Service Bulletin

Subject: 5300 Logic Board Modification Required to Use External Interface

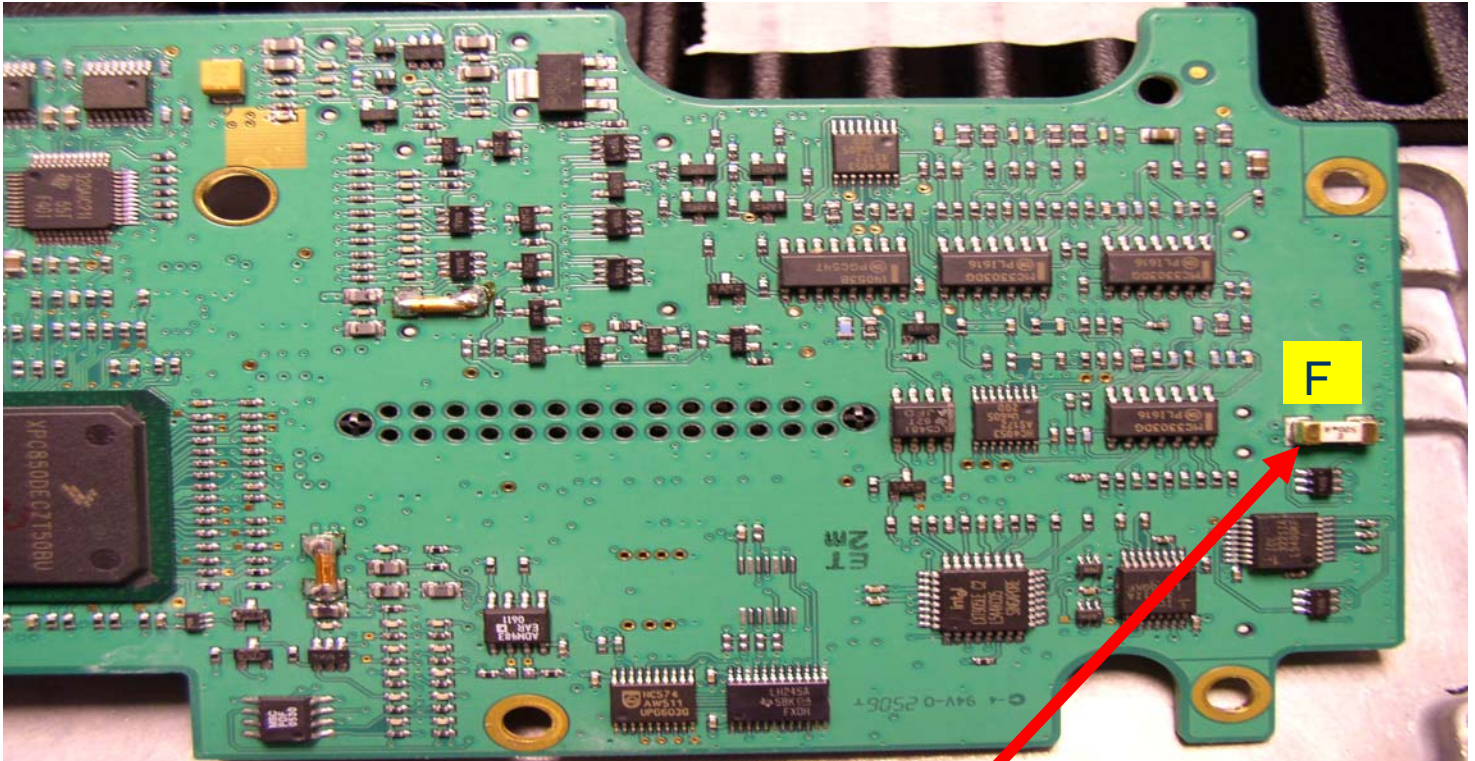
EFJohnson is committed to the continued support of its customers and products. To that end, we are issuing this bulletin so that installers of EFJohnson Motorcycle Radios perform a minor modification for the radio to operate as desired. This modification is required when using the EFJohnson Motorcycle Kit (part number 250-5300-883), for IP25300 interfaces, and for any other application requiring power to be provided through the DB 25 Options connector. Failure to perform this modification will result in a fuse opening and no power being provided to the external device rendering the radio inoperable. Perform the modification required as shown in the following photographs.

Rework Location

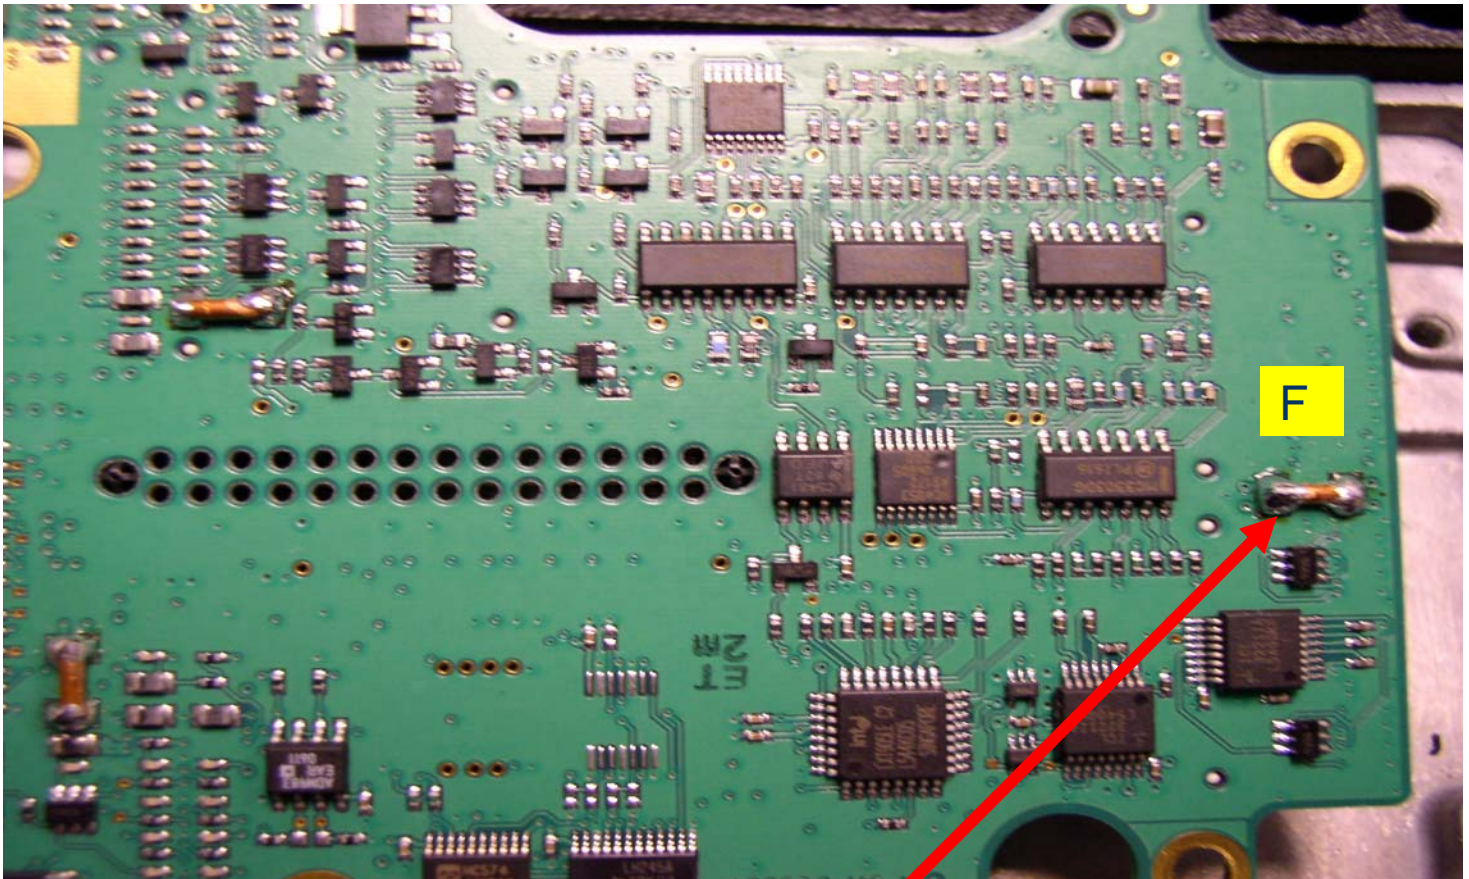
Remove F1 fuse and replace with 1/4" length of 16 AWG bare wire, part number 597-0271-016
